12 December 2024

SSD 67175465  
JD6 (P&E)

**STATE SIGNIFICANT DEVELOPMENT APPLICATION 61000021**  
**146 ARTHUR STREET NORTH SYDNEY**  
**BUILD-TO-RENT PROJECT**  
**APPLICANT: AQUALAND PROJECTS PTY LTD**

***Proposed building's envelope within the current CBD context, viewed from Spruson Street Neutral Bay***

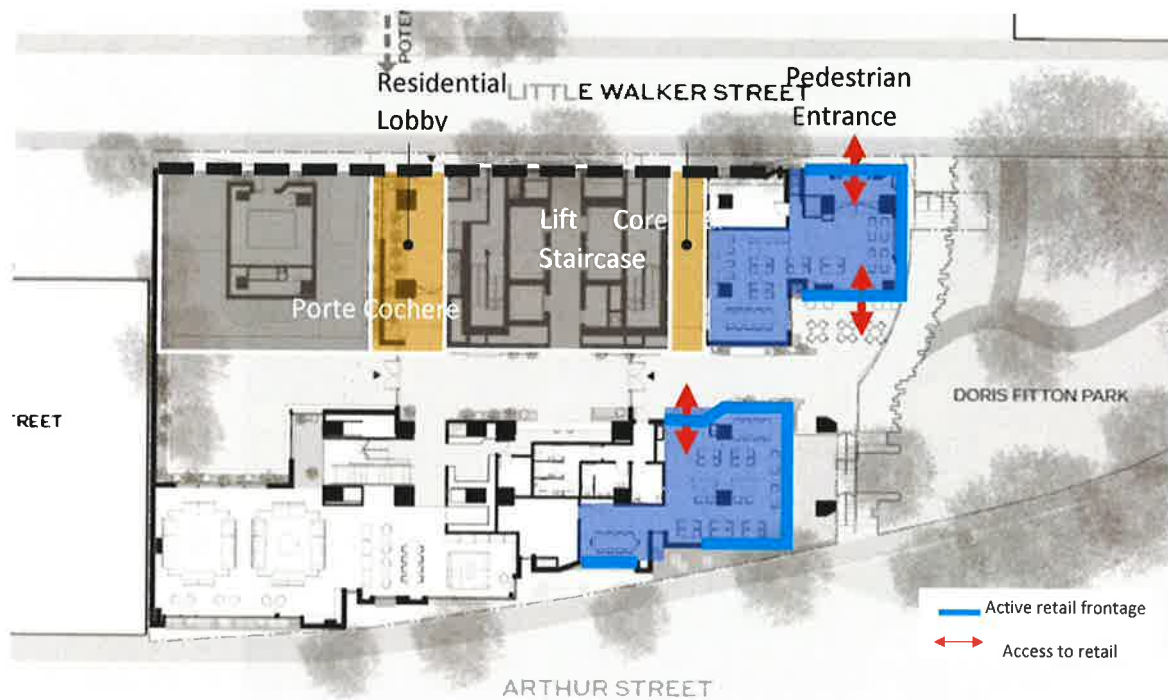
Use of glass and masonry in the façades does not offer any indication that the building is to be used for residential accommodation. Rather, coupled with the towering form, proposed use and distribution of materials renders it's intended use as unidentifiable. Large, glazed areas may be problematic, increasing heat loads on the building.

*View from Doris Fitton Park towards the proposed development*

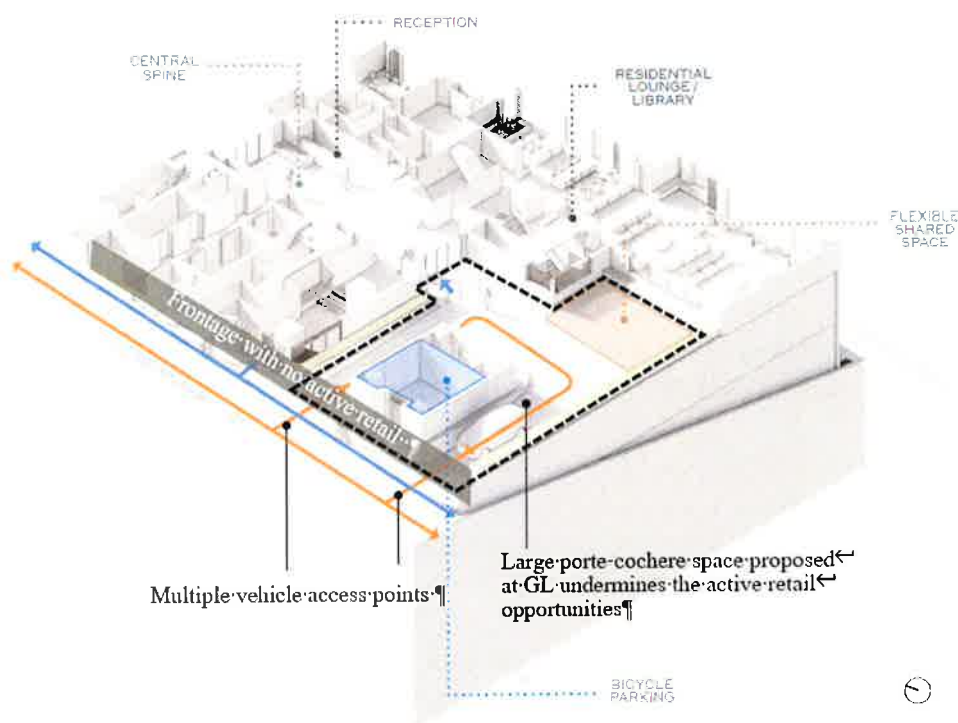
The site is situated directly south of Doris Fitton Park, offering a prime opportunity to leverage its excellent public domain frontage and views. However, the proposed design does not fully utilise this advantage. The restaurants facing Doris Fitton Park lack direct access to the park, with access instead provided through an internal link within the building, shown below. This design approach limits opportunities for outdoor dining areas that could extend into the park, thereby reducing the potential to effectively activate the public domain frontage and create a seamless indoor-outdoor dining experience.

***It is recommended to open up the ground plane towards Doris Fitton Park, establishing active and direct connections between the ground-floor retail spaces and the park. This approach would enhance opportunities for outdoor dining and improve the interface with the public domain.***

***Proposed porte-cochere location at Ground Level***

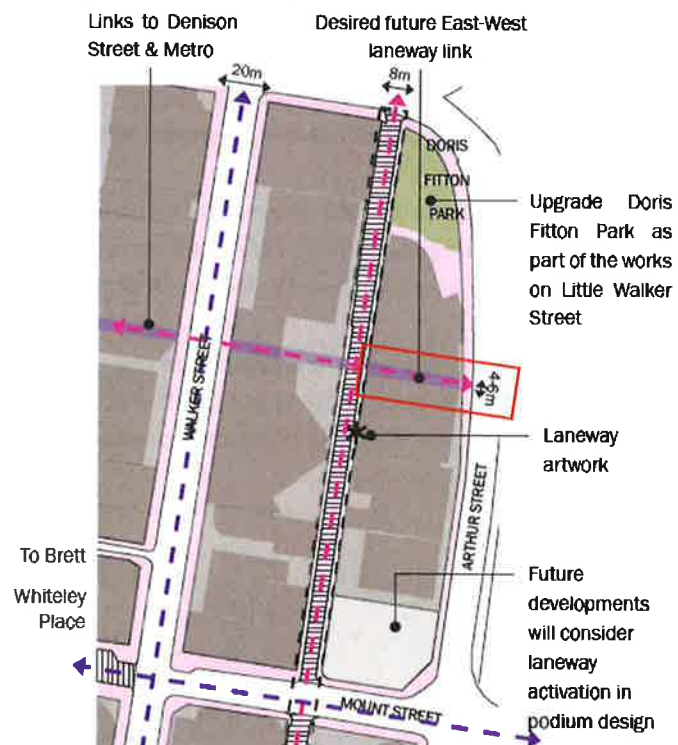
This porte-cochere raises significant design concerns:

- A large section fronting Little Walker Street with no active frontage, which undermines the potential to activate this future pedestrian-prioritised area.
- Multiple vehicle access points on Little Walker Street, in addition to the access on Arthur Street, create unnecessary pedestrian-vehicle conflicts, negatively affecting the streetscape and posing potential safety risks.

***To address these issues, it is recommended to reconsider the floorplan configuration to maximise active retail frontages along Little Walker Street and reduce vehicle access points. If temporary parking is required, it could be accommodated in Basement Level 1 or within a setback area on Little Walker Street (parallel parking), ensuring pedestrian activity and safety are prioritised.***
